**BOARD OF SUPERVISORS
PUBLIC HEARING
STAFF REPORT**

SUBJECT: ZMAP-2020-0005, ZCPA-2020-0008, ZMOD-2020-0020, & ZMOD-2020-0026, Goose Creek Overlook

PURPOSE: To consider a proposal to rezone 46 acres of land currently zoned R-1 (Single Family Residential) to the PD-H4 (Planned Development – Housing 4) zoning district to allow for development of 251 dwelling units, including a maximum of 136 single family attached (SFA) residential units, 40 stacked multifamily (MF) units, and 75 attached MF affordable housing units (AHU).¹ The applicant also seeks to modify the Loudoun County Revised 1993 Zoning Ordinance (Zoning Ordinance) requirements to reduce the minimum number of parking spaces required to serve the project and to permit a number of residential units to front onto open space rather than a street.

Figure 9: Existing and Proposed Infractions w/in 300' No Build Buffer

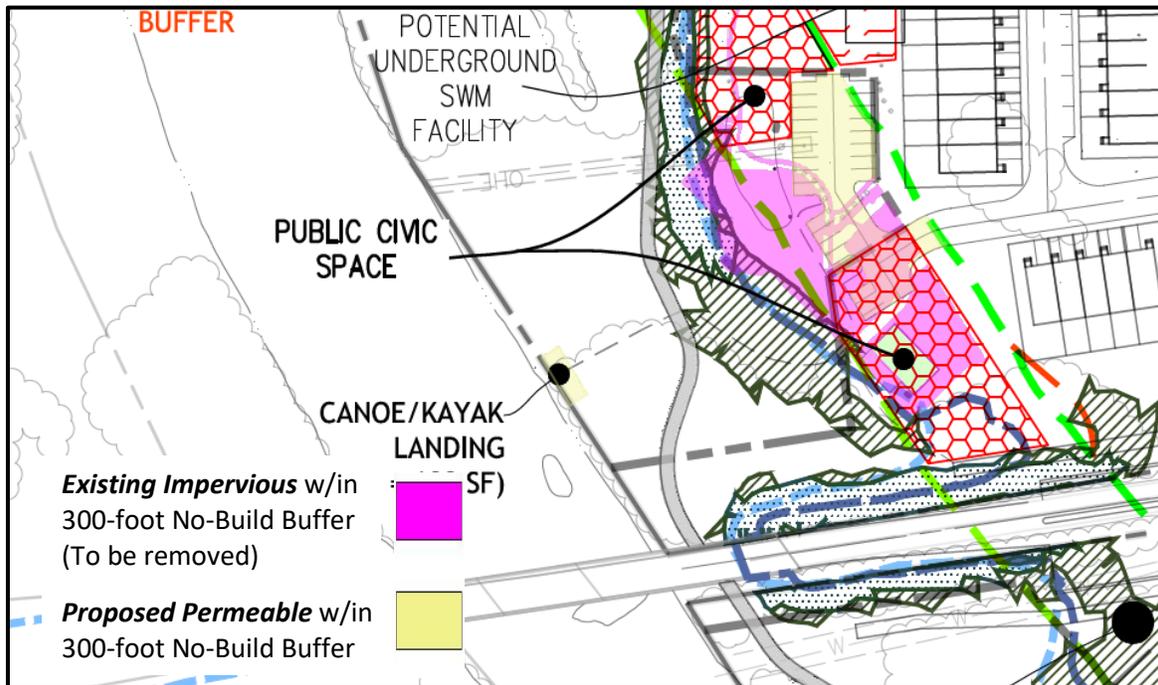
Improvements within the 300-foot No-Build buffer – The proposed CDP depicts improvements – primarily a trailhead parking area – within the limits of the 300-foot “no build buffer” (Figure 9). Environmental policies of the 2019 GP do not support improvements of any kind within the buffer, because the buffer is intended to prevent pollutant loading into the water resource. This particular instance includes the nuance that there is considerable (24,773 SF) existing impervious surface within the buffer already associated with the existing by-right residence on the property. The improvements proposed by the subject applications include a permeable surface parking area and canoe/kayak landing that together comprise less area (8,735 SF) than existing infractions. Staff would not typically support any encroachment into the 300-foot No Build Buffer but acknowledges the uniqueness of this instance, which includes a net reduction in impervious surface, as well as provision of public access to Goose Creek and the associated trail network. Staff recommended during the course of review that the improvements be provided outside of the resource areas. In summary, the proposal is not consistent with 2019 GP guidance to avoid disturbance within the No Build buffer,⁸ but as proposed, would result in a net reduction of infractions. The Commission recommended that the proposed permeable parking area be completely removed from the 300-foot “no build” buffer.

Staff recommends that the Board consider the appropriateness of the proposed permeable parking area that is reduced in size in response to Commission recommendation but remains within the 300-foot No-Build Buffer.

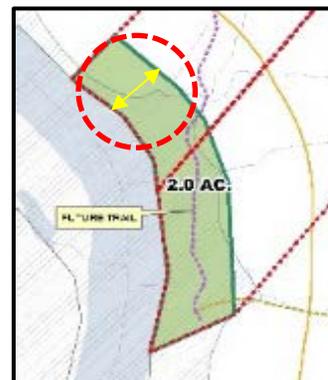
6. Please provide information on the width for the 1.3 acre and 2.0 acre (see below).

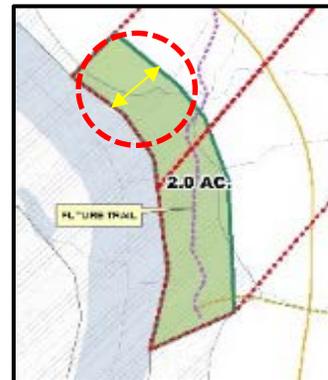
Comment #6 (July 8, 2020). Please provide information on the width for the 1.3 acre and 2.0 acre (see below).

PROPOSED LAND EXCHANGE

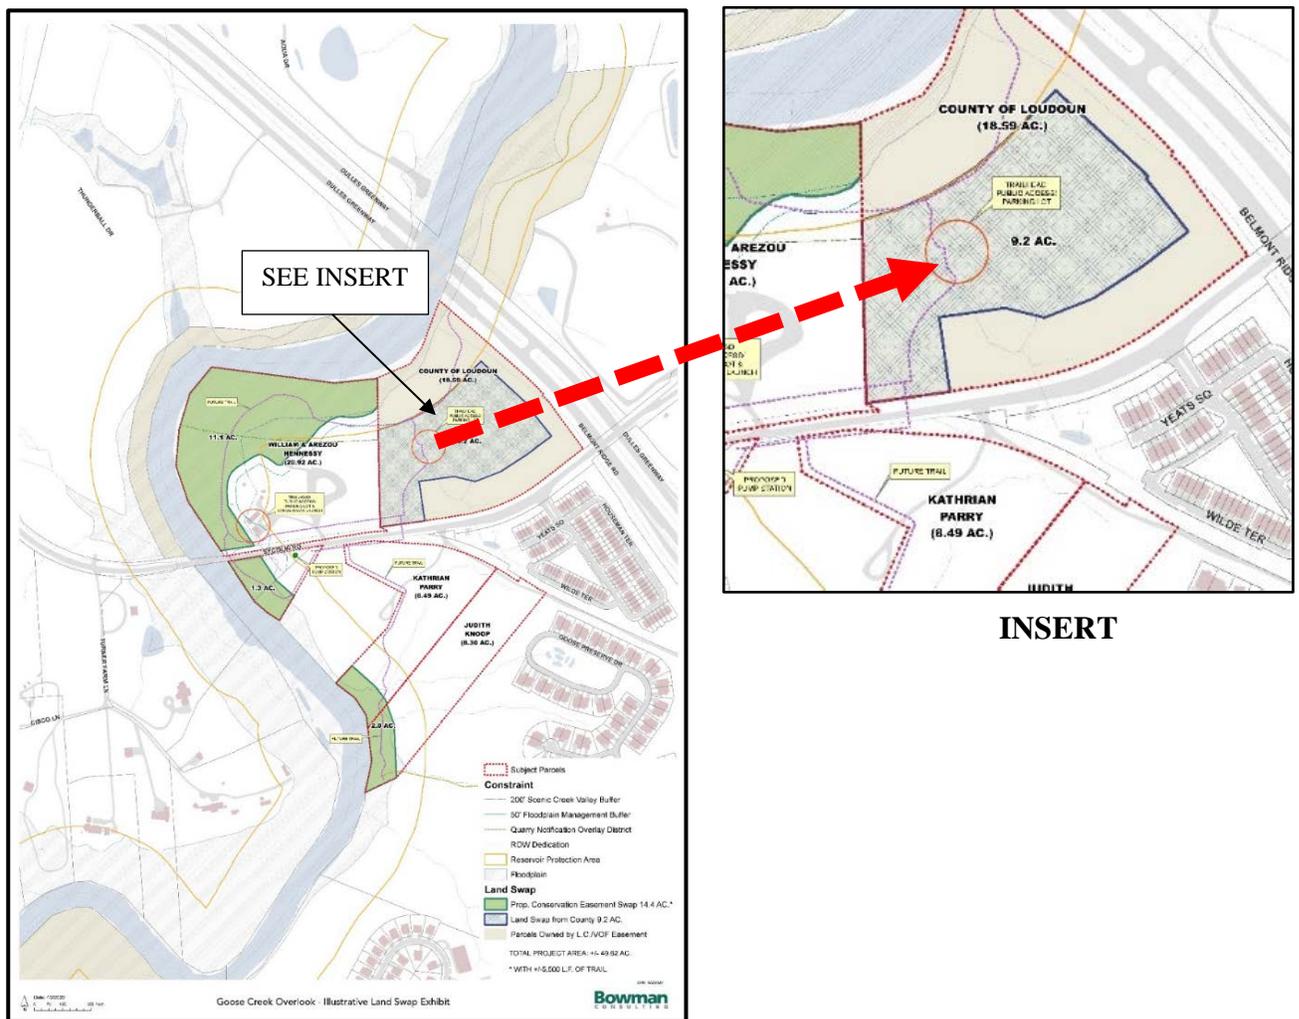
Comment #1 (July 8, 2020). Land Exchange. As stated in the statement of justification, a fundamental and integral component to this project is the applicant's proposal to exchange 9.2-acres of the adjacent 18.54-acre parcel owned by the County (Passive Parkland) with approximately 14.4 acres of the property that fronts Goose Creek as depicted below:

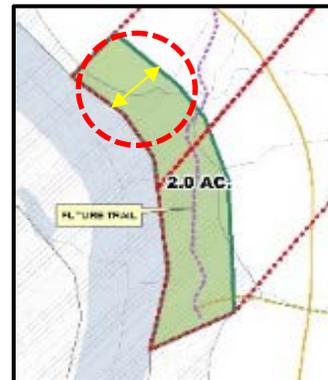
Comment #6 (July 8, 2020). Please provide information on the width for the 1.3 acre and 2.0 acre (see below).
